**SUBJECT:** COMANCHE PEAK NUCLEAR POWER PLANT, UNITS 3 AND 4  
DOCKET NUMBERS 52-034 AND 52-035  
RESPONSE TO REQUEST FOR ADDITIONAL INFORMATION NO. 5947  
(SECTION 3.7.2)

**RAI NO.: 5947 (CP RAI #226)**

**QUESTION NO.: 03.07.02-23**

**QUESTION NO.: 03.07.02-24**

Figure 1 - Transfer function for PSFSV Node 1872, lower bound - no fill, east west (x) response, original frequencies. Black dots represent calculated values.

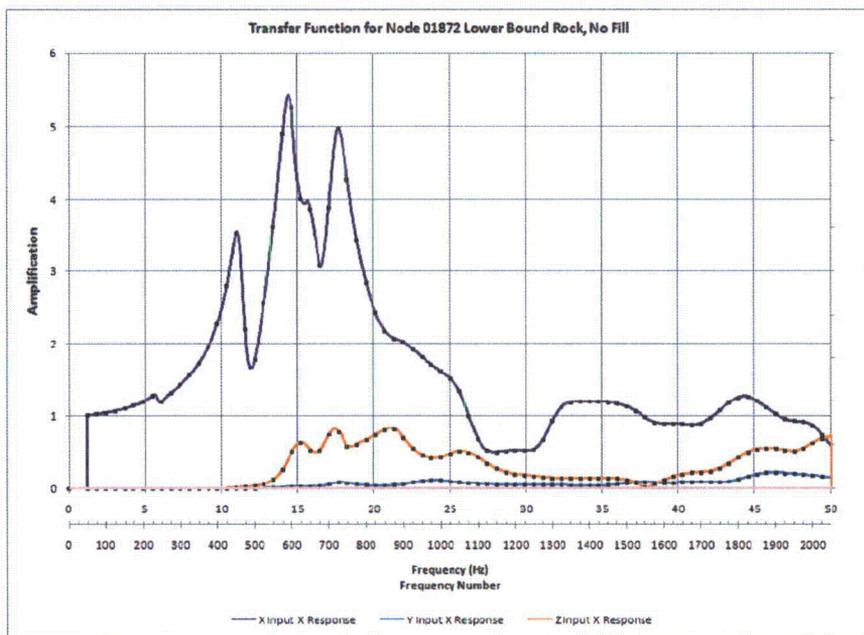
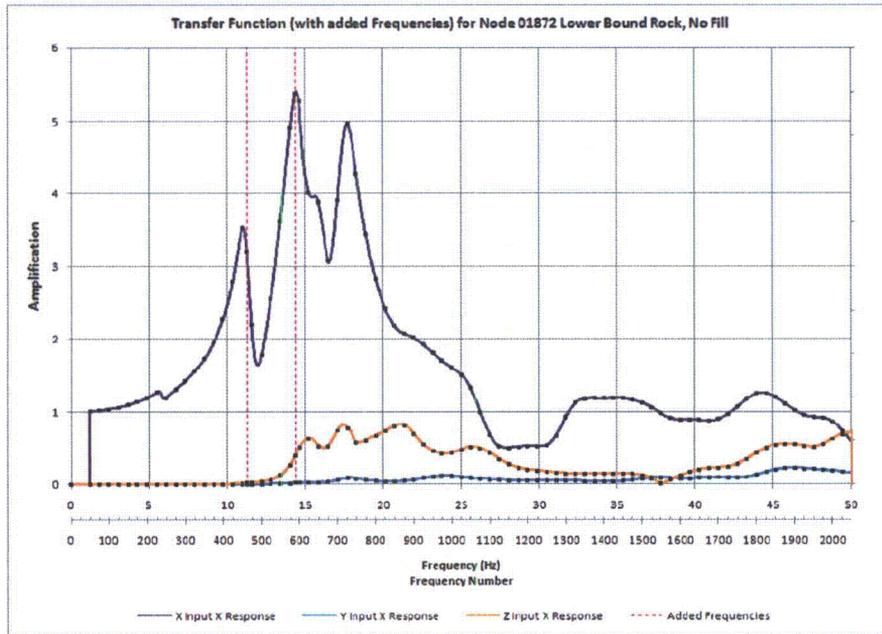
4. In the response to item 4, the applicant stated that frequencies were added to the SASSI analysis as needed to produce smooth interpolation of the transfer functions to accurately capture peaks, and additional frequencies were added to observe that the results did not change. The addition of analysis frequencies to capture peaks does not appear to be reflected in Figures 1 through 12. The applicant is requested to update any analysis frequencies as required and provide such information to the staff for review and update Figures 1 through 12 on your response.

4. Figures 1 through 12 shown in the response to RAI 2879 (CP RAI #60) include all frequencies added after the review process. Consideration of additional frequencies beyond those shown in the figures was studied during the design. The primary study of the effect of sharp frequencies was performed on the PSFSV structure. Based on additional frequencies, it was determined that the changes in sharp interpolation errors and sharp peaks are not significantly affected by

additional frequencies. See Figure 1 for the transfer function with original frequencies and Figure 2 for the transfer function with added frequencies. This exercise was performed at a number of locations to demonstrate the sufficiency of the spacing of the frequency calculations to accurately predict the intermediate values.

Figure 3 - Comparison of Transfer Functions at Node 1378 for Four Soil Cases at Tunnel Segment 1, X Response due to X Input

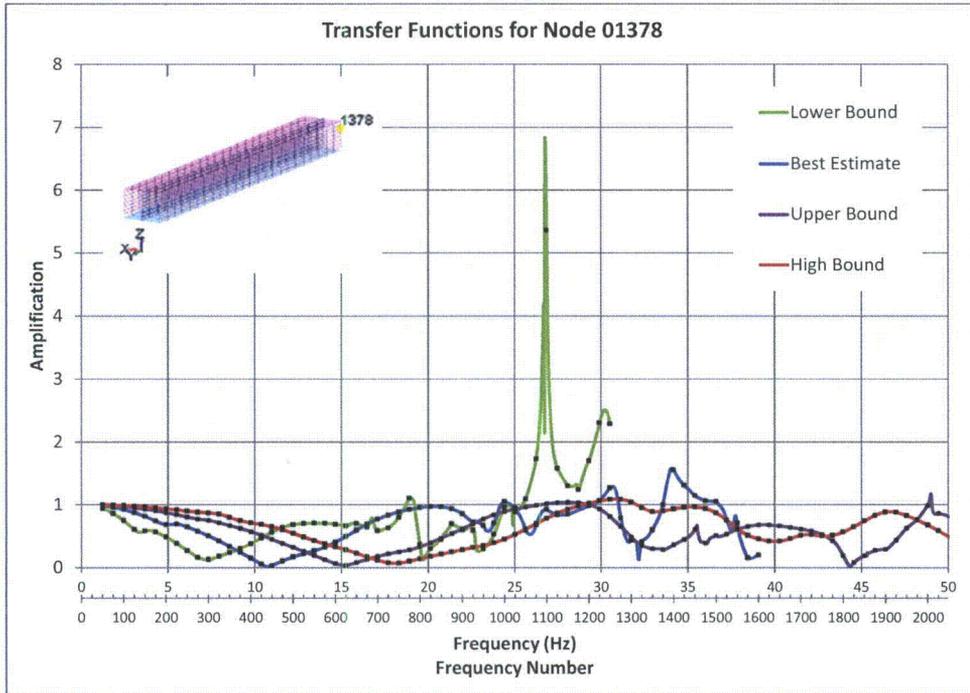
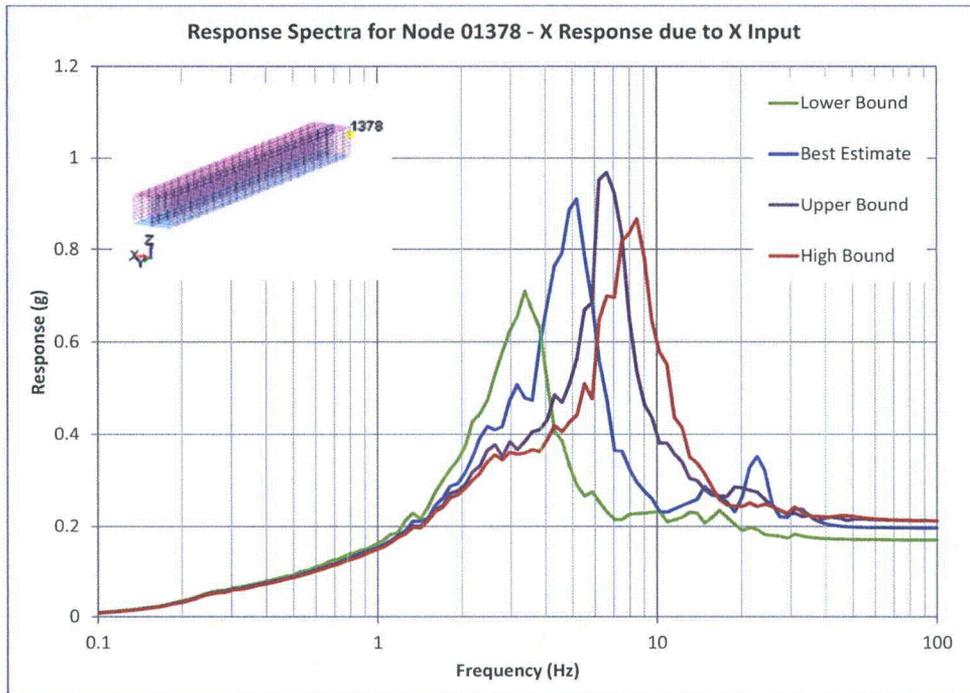
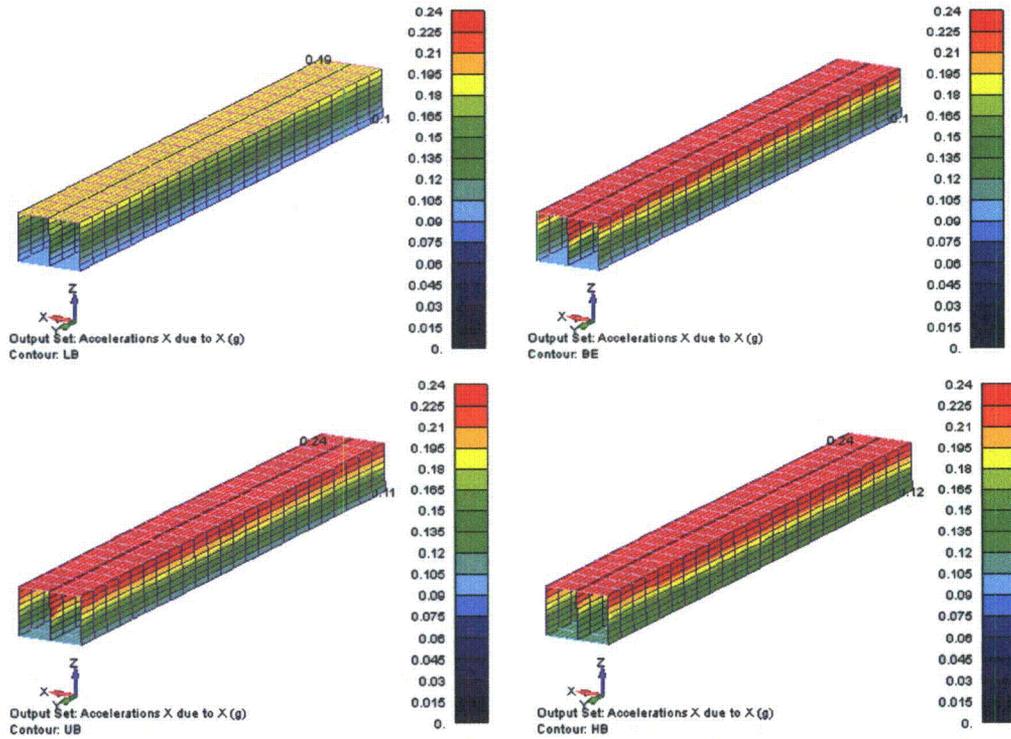
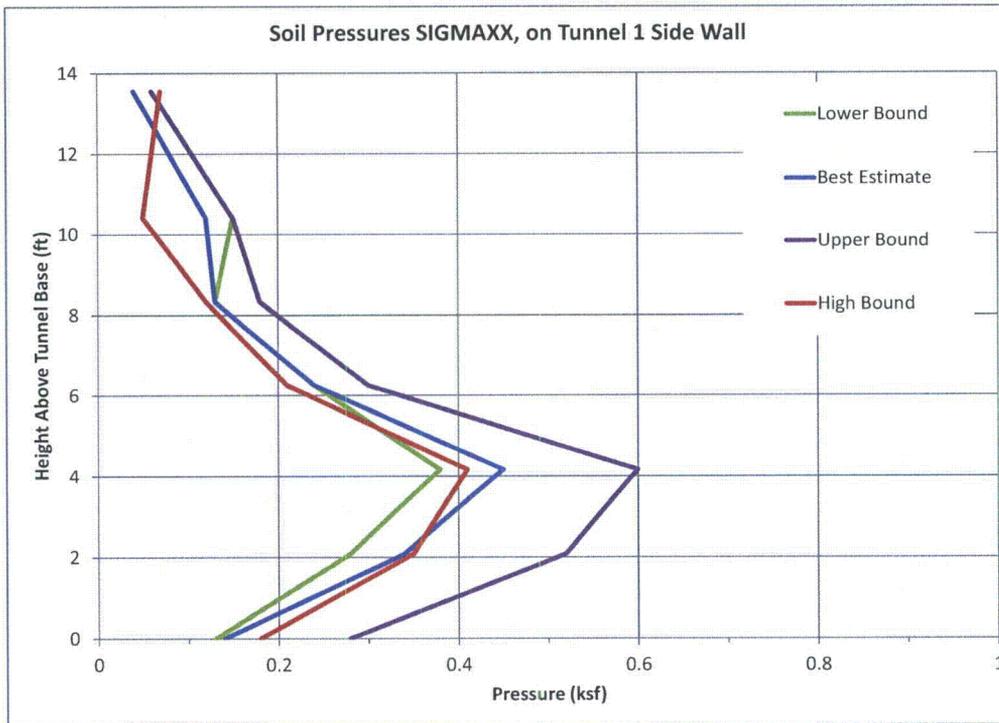
8. In the response to item 10, the applicant mentions the examination of transfer functions to verify that interpolations were reasonable and also mentions comparisons between transfer functions, spectra, accelerations, and soil pressures for the various soil profiles. The applicant is requested to provide comparisons of the interpolated and uninterpolated transfer functions to the staff for review and to state the acceptance criteria for the transfer functions. The applicant is also requested to provide the comparisons of transfer functions, spectra, accelerations, and soil pressures for the various soil profiles to the staff for review.

8. Transfer functions provided in RAI 2879 (CP RAI #60) Question 03.07.02-16 (ML093340447) include dots showing the calculated transfer function values. The lines in the plots show the interpolated transfer function values. Transfer function reviews were performed to observe that the low frequency response approached 1.0 for response in the direction of input motion and approached 0.0 for cross-terms. The transfer functions were reviewed to determine if the interpolations were reasonably smooth without major interpolation peaks that are not justified by adjacent calculated values. Narrow peaks less than about 1/4 Hz were typically considered to be too sharp to significantly affect the response and were considered acceptable because the potential error is conservative. High frequency peaks were considered to be acceptable because the input motion contains less energy at high frequencies, and therefore the effect of transfer function peaks is less significant at higher frequencies.

Comparison of transfer functions and response spectra at Node 1378 for all four soil cases and X response due to X direction input are shown in Figure 3 and Figure 4, respectively. The comparisons of transfer functions show very similar trends for each of the soil cases at low frequencies. At higher frequencies there is more variation. For example, the lower bound soil diverges from the smooth trend around 17 Hz resulting in numerous peaks and valleys and a sharp peak around 27 Hz. However, the response spectra comparison shown for the same node does not reflect this higher frequency response, likely because of the lack of time history input energy at these higher frequencies. The response spectra show very similar responses with shifted peaks due to the variation in soil properties. As expected, the stiffer soil cases generally control at higher frequencies. Comparisons of nodal accelerations are shown in Figure 5. These comparisons show similar response for each of the soil cases with no unusual results identified in any of the soil cases or nodal locations. Comparison of soil pressure on the side of Tunnel Segment 1 near the center of the tunnel is shown in Figure 6. The upper bound soil case results in the highest soil pressure, but other soil cases show similar shape and magnitude.

**Figure 7 – 5% Damped Response Spectra for Each Soil Case at Node 1956 (PSFSV Roof), East West (x) Response**

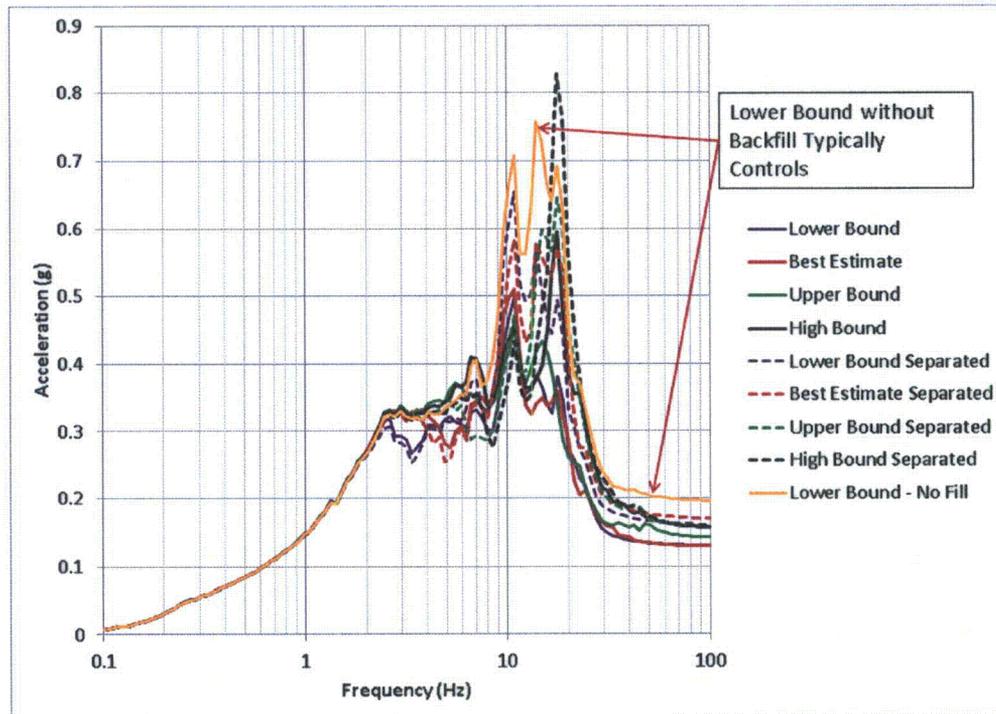
7. Tables 12, 13, and 14 indicate that the maximum passing frequencies for numerous soil layers are less than 50 Hz, which is the frequency recommended in ISG-01 for SSI and structural models. The applicant should provide justification that the use of lower passing frequencies in the soil leads to accurate or conservative results for the SSI analysis.

10. Table 18 of RAI 2879 (CP RAI #60) provided the passing frequencies of a wave passing through the soil layers under the 1/5 wavelength criteria. The input motion was applied at the top of rock, which is also the foundation support level. The primary path for seismic motion is vertically propagating through the base slab at rock level. The rock layers pass frequencies near or above the cutoff frequencies used. Although the backfill soils do not pass frequencies as high as the cutoff frequencies used, the analyses did not show abnormal behavior beyond the passing frequencies because the structural input does not rely on these soils to excite the structure and all time history energy is mostly at low frequencies. While significant differences are observed for different soil cases, the cases with less soil support (separated and no backfill) controlled, particularly at high frequencies, as shown in the example in Figure 7 below. Hence the passing frequencies used are adequate for this analysis.

Figure 1 - Response Spectra Generated at Top of Rock - Embedded Condition

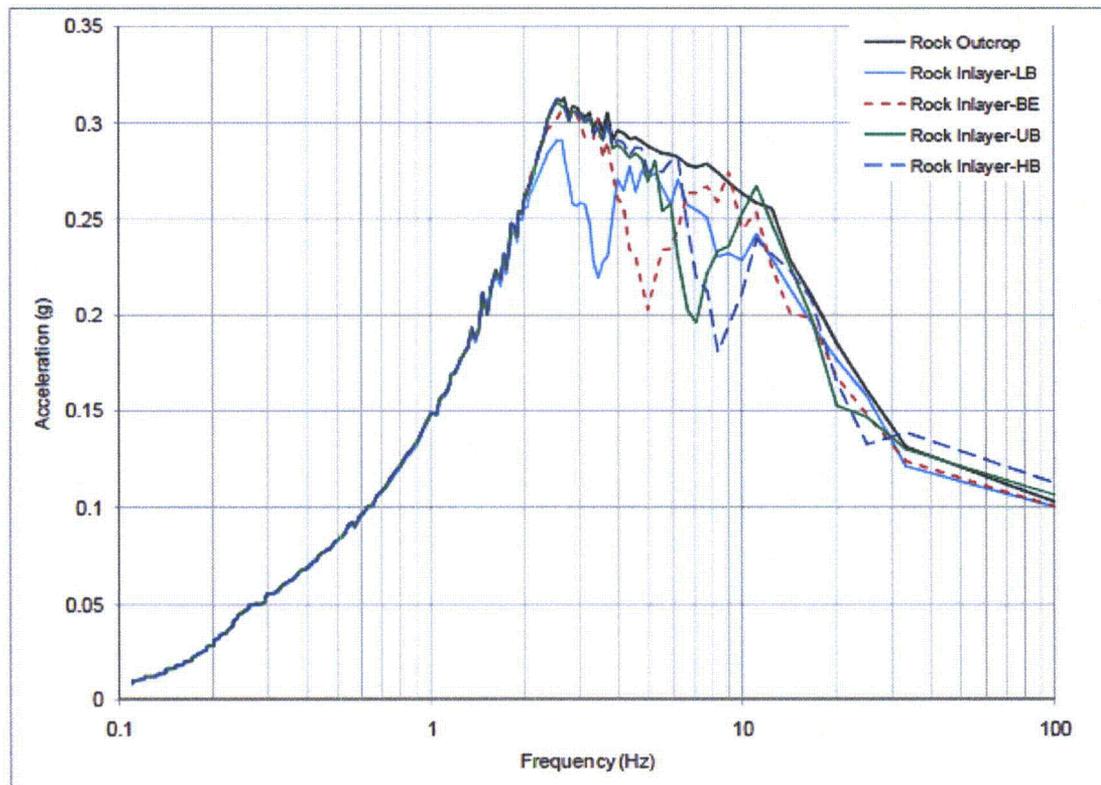
1. The input motions or spectra used in the evaluation of the UHSRS in Appendix 3KK are never shown or defined. The applicant is requested to show plots of the input spectra used for the SSI analyses.

1. The dynamic SSI analysis of the UHSRS was performed using SASSI to generate ISRS, and seismic acceleration responses. The structural design of the UHSRS was analyzed for response spectra seismic input and static loadings using ANSYS. The results of the response spectra analyses were compared to the results of the SASSI analyses to confirm the adequacy of the seismic demand used for evaluation of the UHSRS. These inputs to SASSI and ANSYS are presented below:

For the embedded condition (backfill condition), the time history motion is computed from an ACS SASSI SOIL module (SHAKE type) analysis to account for the strain-compatible effects of backfill. The SSI analyses performed with SASSI for the UHSRS requires in-layer time history motions as input. This time history motion input at the bottom of structural model location is an outcrop motion and is input to the SOIL module. The SOIL module calculates in-layer motion at the top of the rock layer for use as input to the SASSI SSI analyses. The outcrop motion is used as the vertical time history input for the embedded condition SSI analyses. This outcrop motion is conservative relative to an in-layer motion. The following spectra plot in Figure 1 presents the time history input motions after conversion to response spectra for the embedded condition:

Figure 2 - Comparison of Base Response Spectra in X-direction (E-W) used for Design with SASSI Results for each soil case

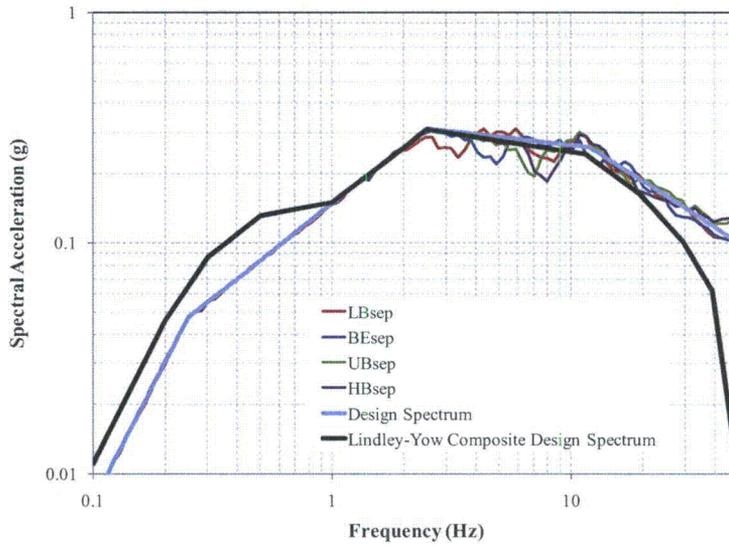
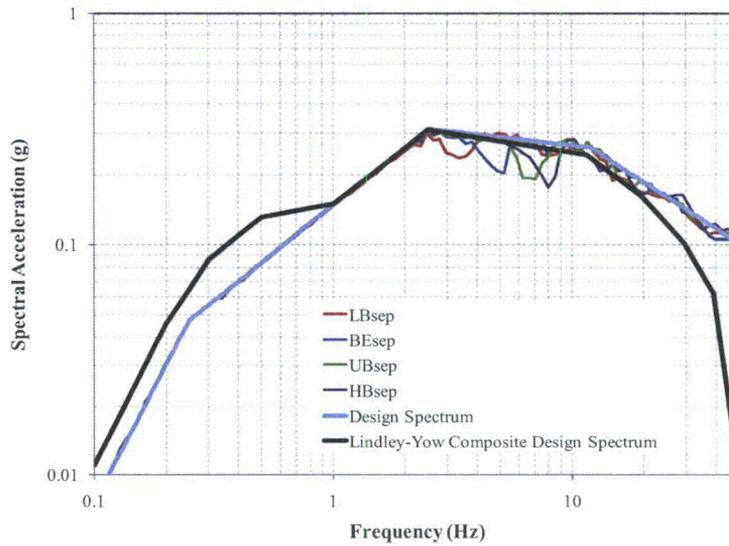
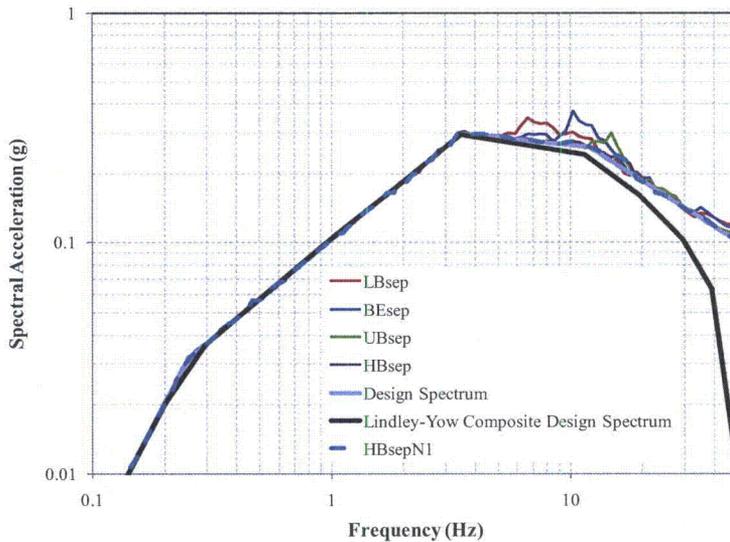
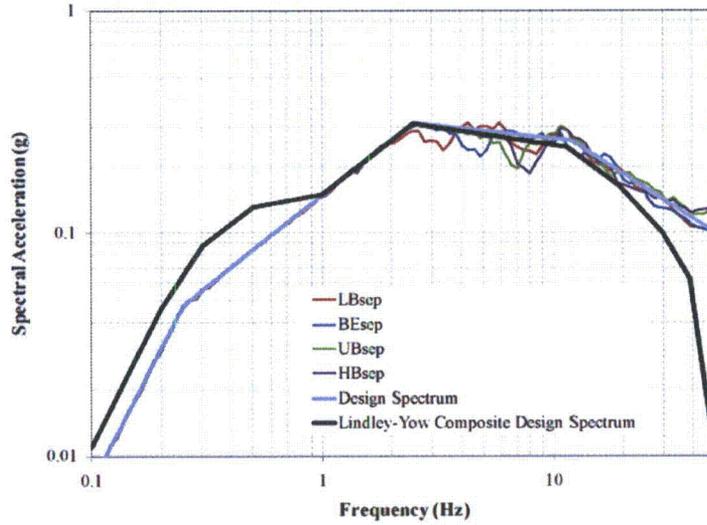
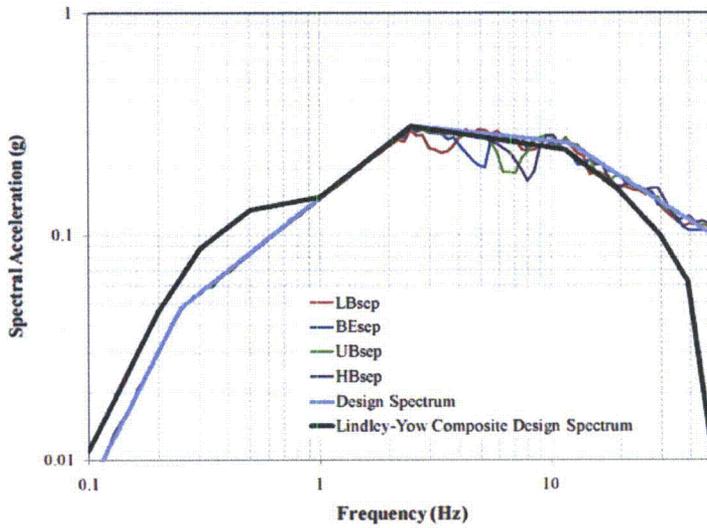
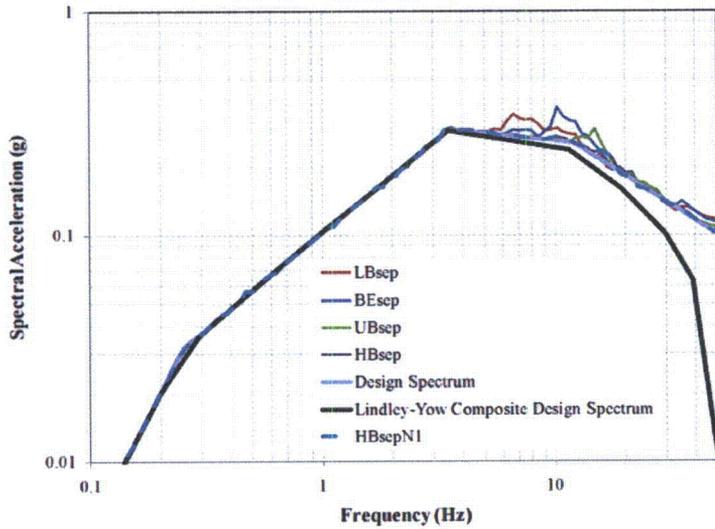
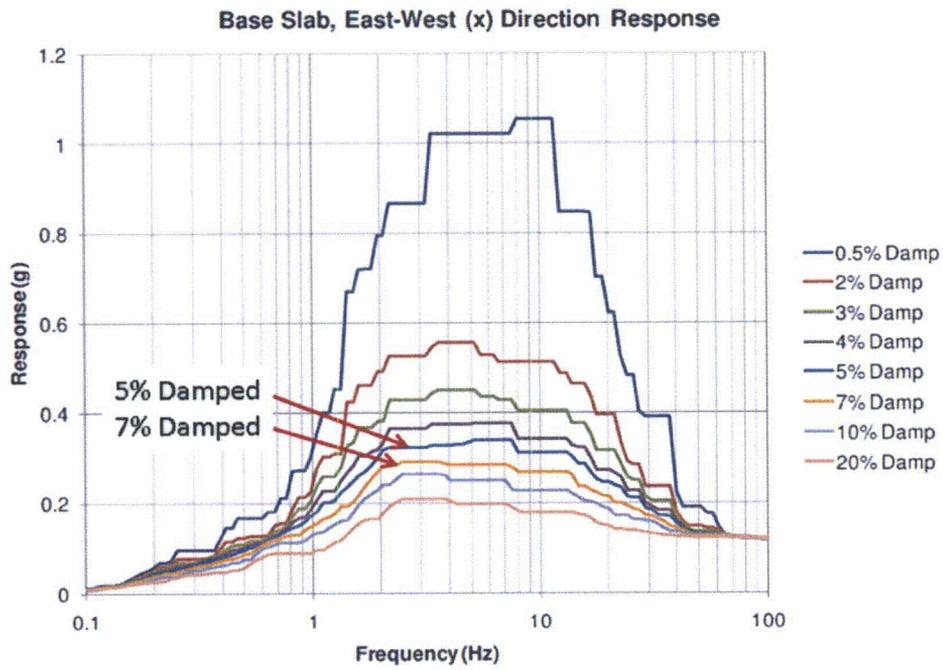
3. The first sentence on p. 3KK-5 states that the spectra used for this approach were confirmed to be higher than the enveloped base spectra calculated from the SASSI analysis. The applicant is requested to provide the comparison between the referenced spectra and the SASSI spectra.

3. The purpose of the design analyses was to produce design demands, and therefore the only requirement is that the demands are correct or conservative. The adequacy of the use of the input spectra to produce design demands is verified by the comparison of the resulting element demands to the demands calculated in SASSI. This comparison is shown in response to RAI 4542 (CP RAI #167) Question 03.08.04-66 (ML102240246). As a result the design spectra are adequate for use as input to determine design forces.

The comparisons of the spectra requested are shown in the following figures. The base spectra computed in SASSI were compared to those used for the response spectra analysis used in design. The comparisons of 5% damped spectra (Figure 5, Figure 6, and Figure 7) show that the SSI spectra are close to those used for design. Since the 5% damped input spectra was used for the analyses rather than the 7% damping by RG 1.61 Table 1 for SSE, the SASSI 7% damped spectra should be compared to the design input spectra. The comparison of SASSI spectra for various levels of damping are shown in Figure 8, demonstrating that the 7% damped spectra is significantly below the 5% damped spectra.
